## Descriptive Report

*Field No.* \_\_\_\_\_ **H12115** \_\_\_\_\_

*Registry No.* \_\_\_\_\_ **OPR-R144-KR-09** \_\_\_\_\_

*General Locality* \_\_\_\_\_ **Central Bering Sea** \_\_\_\_\_

Figure 1 – Overview of H12115 with Chart 16011, 3<sup>rd</sup> Edition, July 2009. Soundings in Fathoms

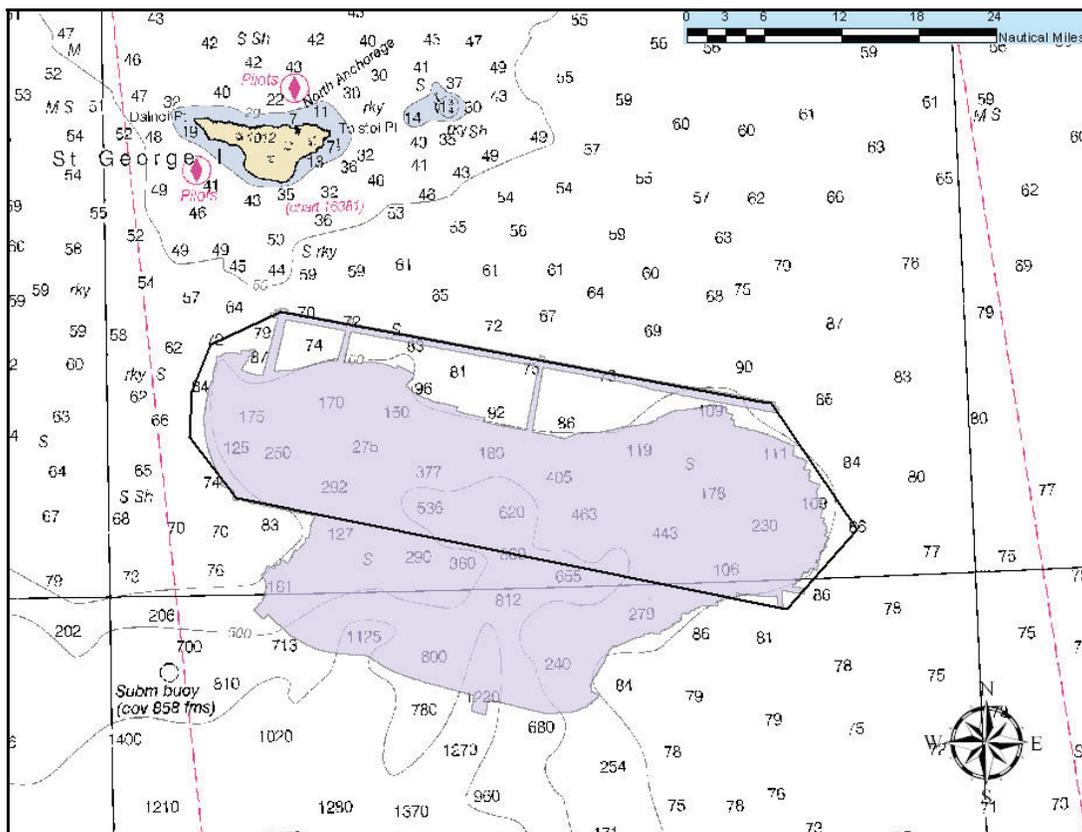
Full bottom coverage, consisting of 100% multibeam data was achieved within the limits of hydrography for this survey. One hundred percent backscatter data was acquired and stored by TerraSond, Ltd to be processed by the client. This survey has a minimum depth of 124 meters and a maximum depth of 2304 meters corrected to Mean Lower Low Water (MLLW) tidal datum. The *R/V Mt. Mitchell* collected 2660 lineal nautical miles of mainscheme multibeam lines and 211 lineal nautical miles of crosslines between June 4, 2009 and June 18, 2009 for a total of 938 square nautical miles of coverage. Bottom samples were not required. *Concur.*

For an image of the complete survey limits, refer to Figure 1.
